THE COST OF COMPROMISE

Response to Revised Application Materials

B-1C Rezoning Request — 473 South Main Street, Harrisonburg, Virginia

“The Link” — TCP Link Harrisonburg, LLC / Timberwolf Capital Partners

Figure 2. Eastbound on Paul St. at Mason St.

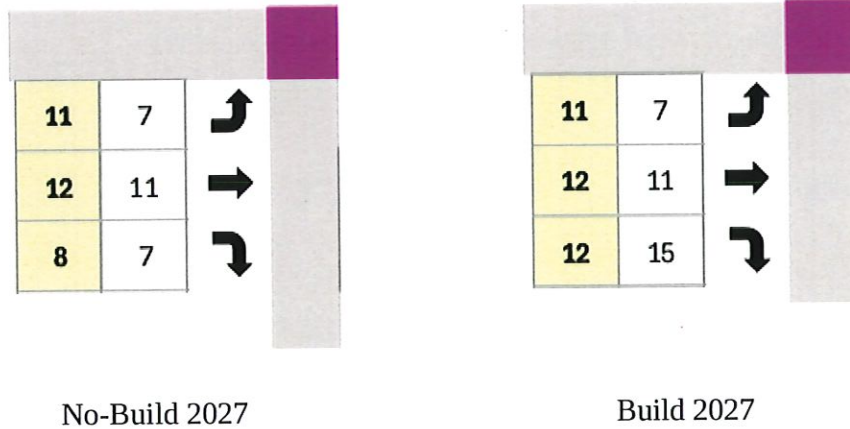
Second, the thru and left turn movements in the "Build 2027" model eastbound on Paul St. at Mason St. are also identical to those in the "No-Build 2027" model.

This ignores the fact that some percentage of the trips from the proposed project to East Campus, the Walmart Shopping Center, and E. Market St. shopping will use Paul St. to get to MLK Jr. Way. In addition, the right turn movements are assumed to increase by 4 during the peak and 12 during the off-peak. This means that the model assumes very few trips from the proposed project to West Campus will use Paul St. to get to S. Mason St.

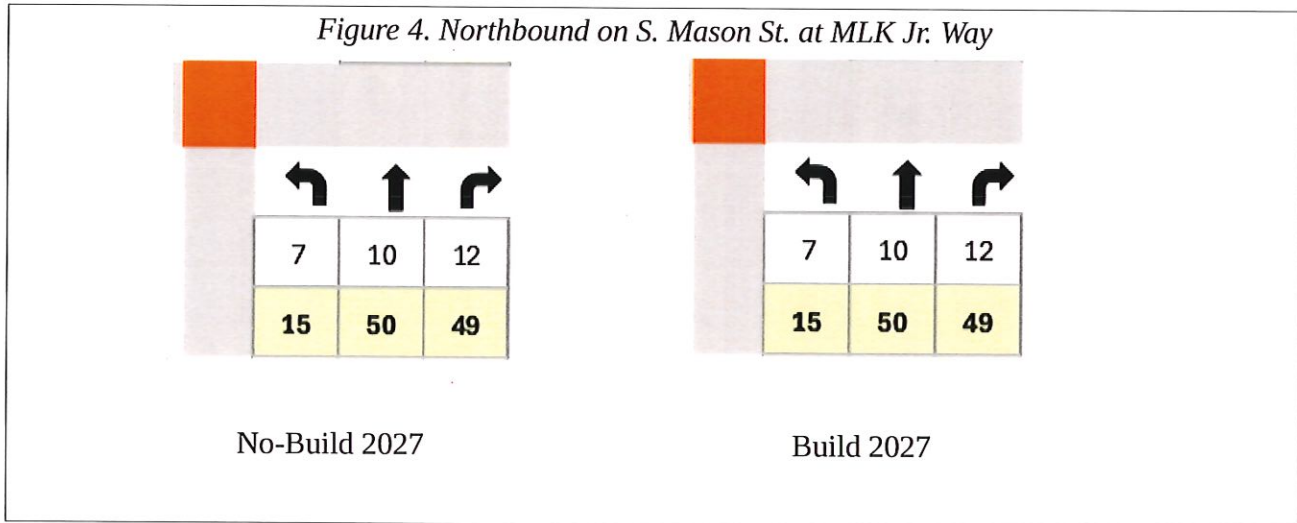
It is not clear what the origins and destinations of the current trips are, but it seems very unlikely that the number won't increase as a result of the proposed project

Map 1. Some Alternative Paths/Routes from The Link to Target

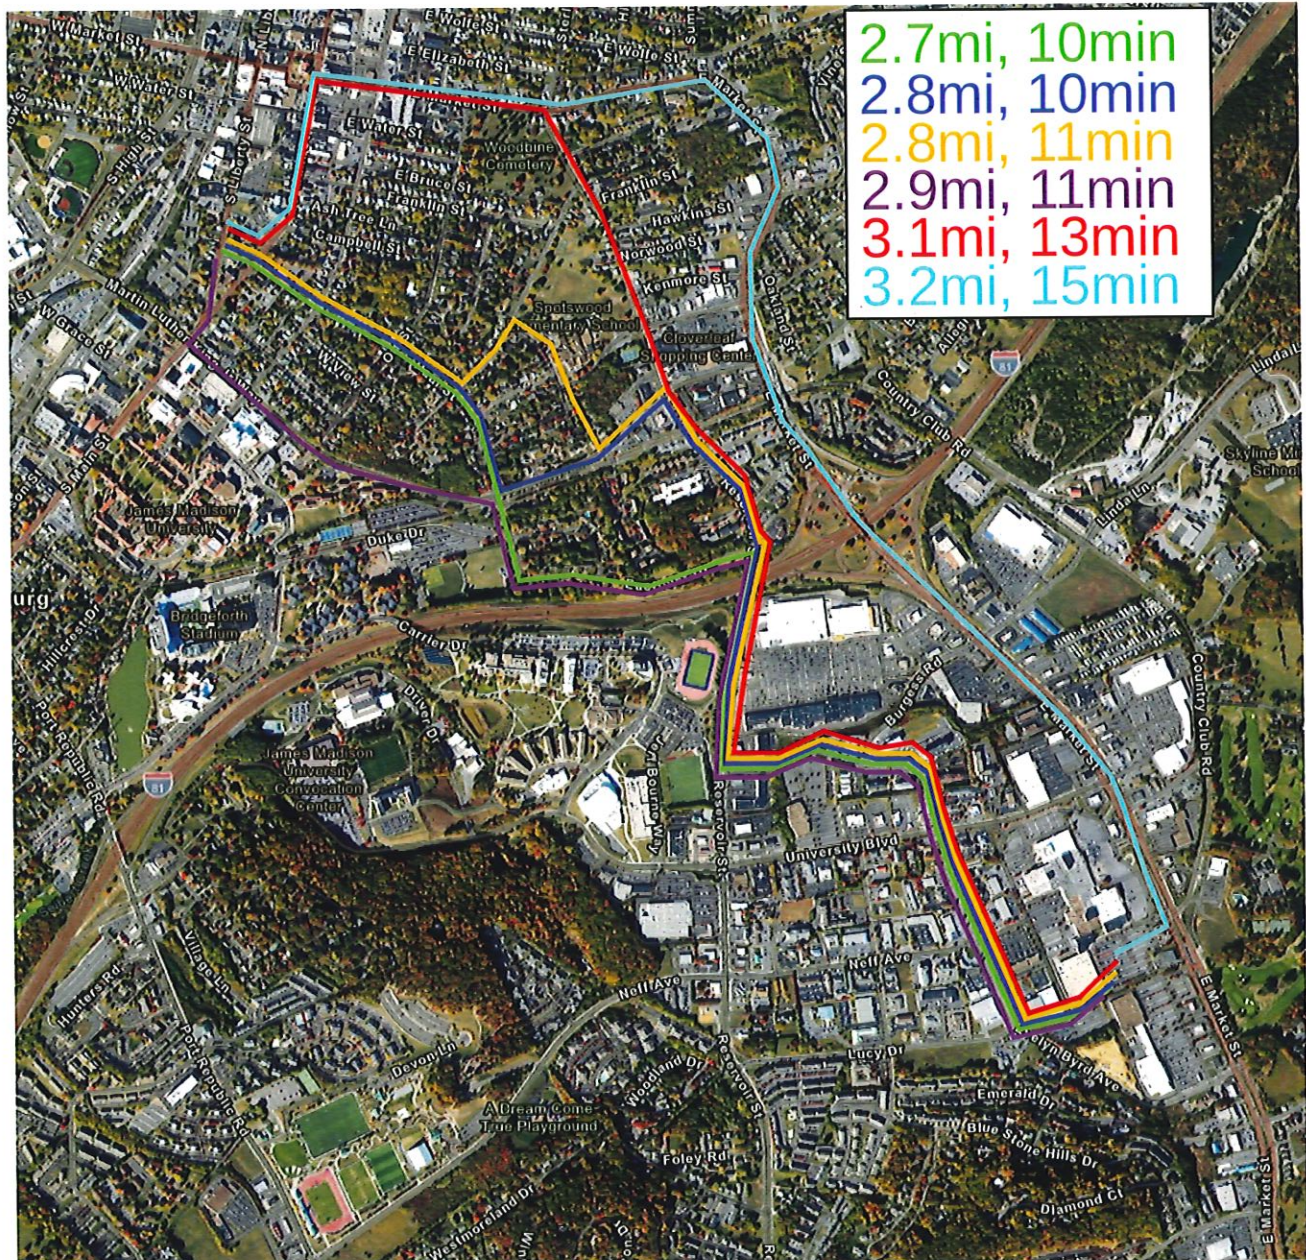
These shortcomings are, in large part because the original TIA (dated March 2025) did not take route/path choice decisions into account at all. As an example, the following figure illustrates the approximate lengths and travel times from The Link Apartments to one likely destination, Target.

As shown in Map 1, there are many paths/routes from The Link Apartments to Target that have very similar lengths and travel times, and hence are likely to be considered viable alternatives.

Map 3. Overflow On-Street Parking Near The Link

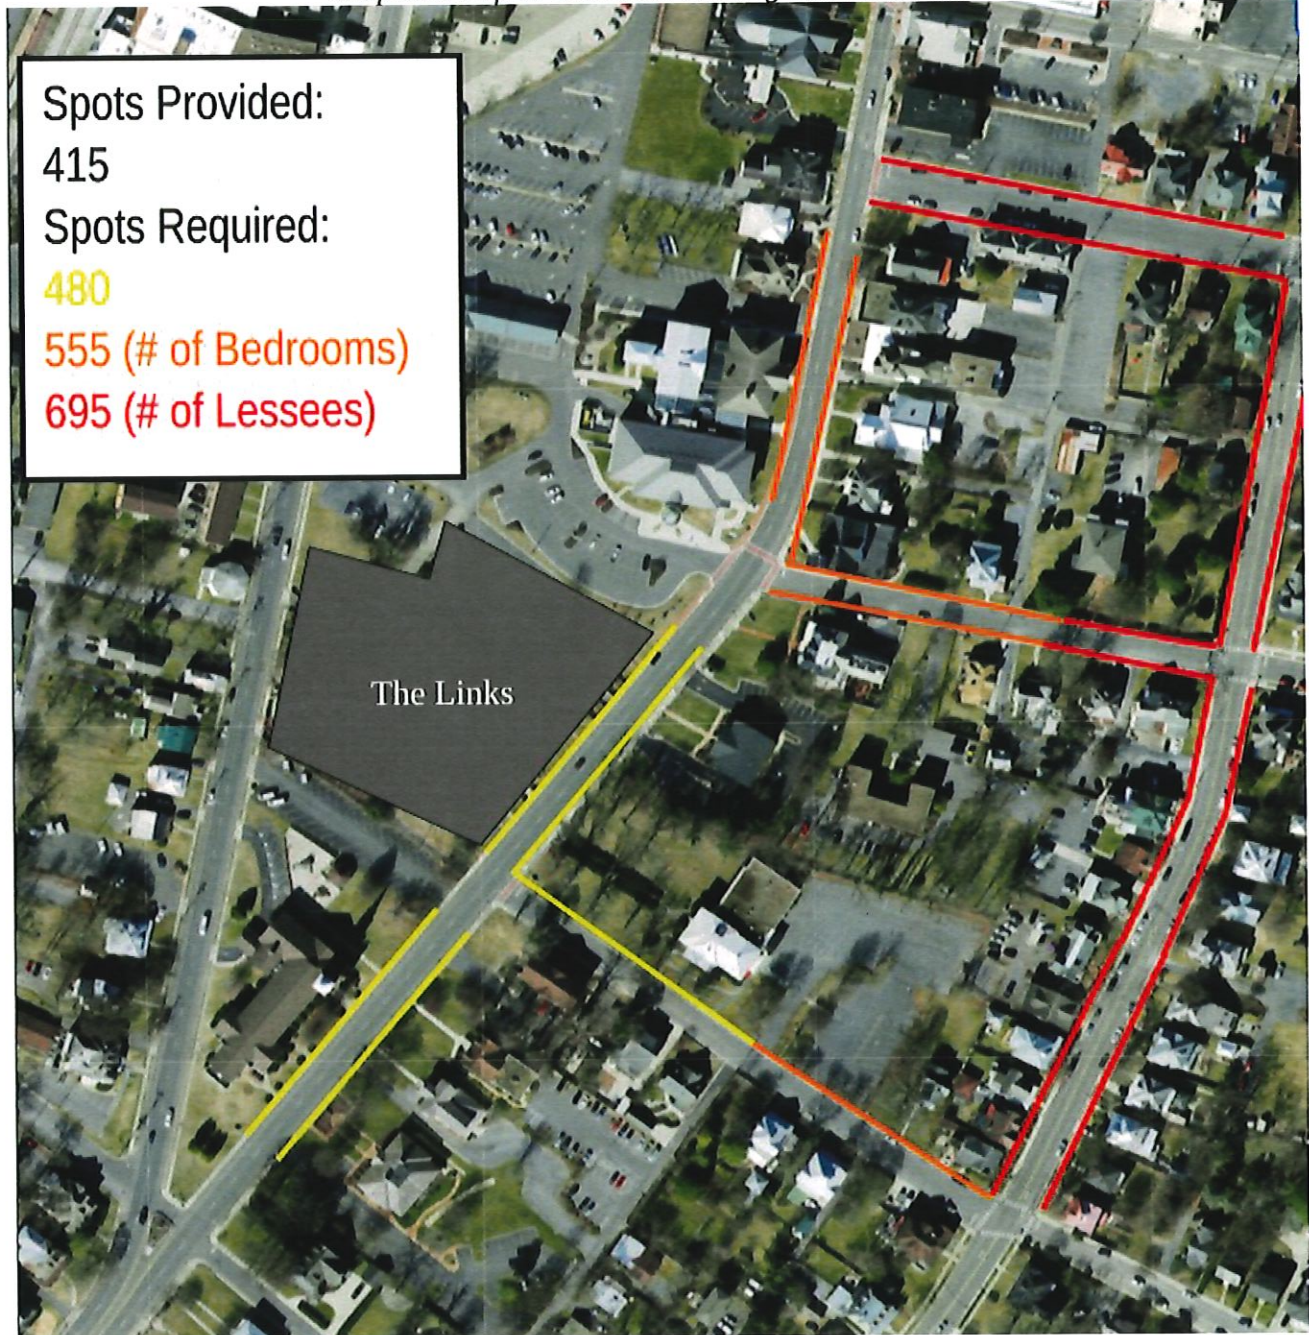
If, in fact, all 480 spaces are required by residents, the closest 65 on-street spaces are on Main St. and Paul St. (as shown in yellow on Map 3). If, instead, there is one car per bedroom (as is possible in a complex in which the residents are college students and/or unmarried professionals), then 555 spaces will be required. The next closest spaces are farther north on Main St., and on Campbell St. (as shown in orange on Map 3). If, in fact, there is one car per lessee, then 695 spaces will be required (with the next closest spaces to the complex shown in red on Map 3).

Of course, many of these spaces are already used by existing residents and shoppers. Hence, either the existing residents and shoppers will be displaced, or the residents of the new complex will have to park farther away. **It is also important to note that the amount of traffic generated by people circling for a space is likely to be significant.**

Photo 1. Overhead View of Paul St. and S. Main St.

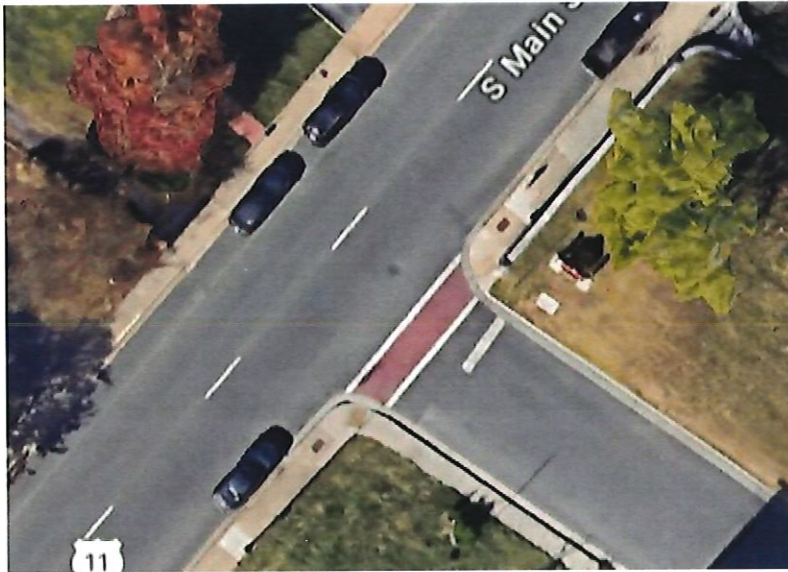
At the location of the proposed extension, Paul St. will go from a wide segment (on the east side of S. Main St.) to a narrow segment (on the west side of S. Main St), and the two segments may not align well. This is illustrated in Photo 1 and Photo 2.

Photo 3. Overhead View of Paul St. and S. Mason St.

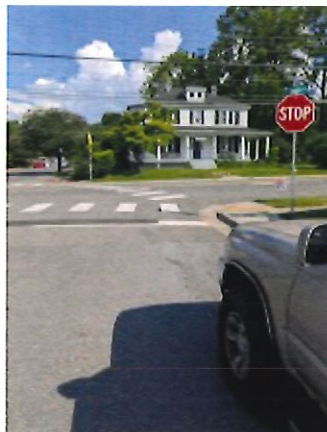
Similarly, at the intersection of Paul St. and S. Mason St., Paul St. goes from a wide segment (to the west of S. Mason St.) to a narrow segment that contains traffic calming measures, and the two segments do not align on the south side of the intersection. This is illustrated in Photo 3 and Photo 4.

Photo 6. Paul St. and Ott St.

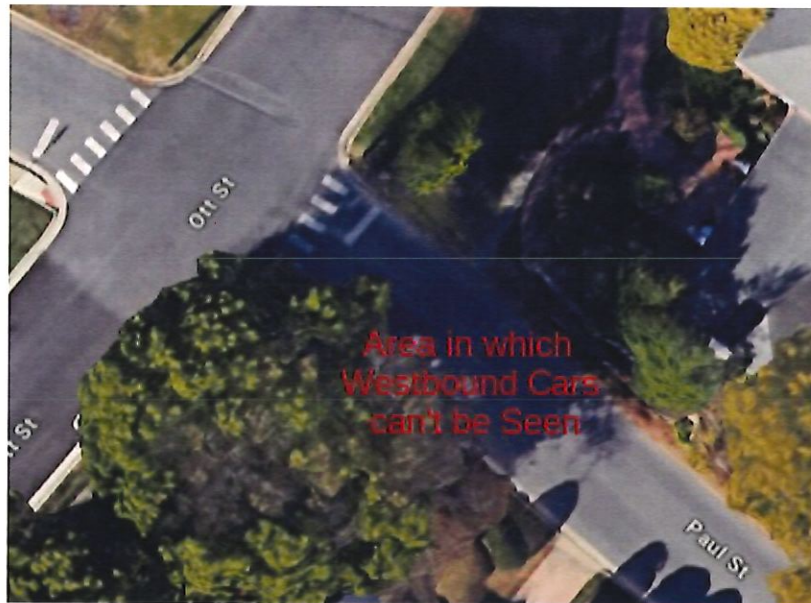
Finally, though it varies, the grade of Paul St. is quite steep in places. This is particularly true in and around the intersection with Ott St. This causes a large number of problems when the road is slick, but also causes problems under normal conditions. In particular, when crossing Ott St. on Paul St. in the eastbound direction, there is a fairly large area in which it is impossible to see oncoming cars. This is illustrated in Photo 6.
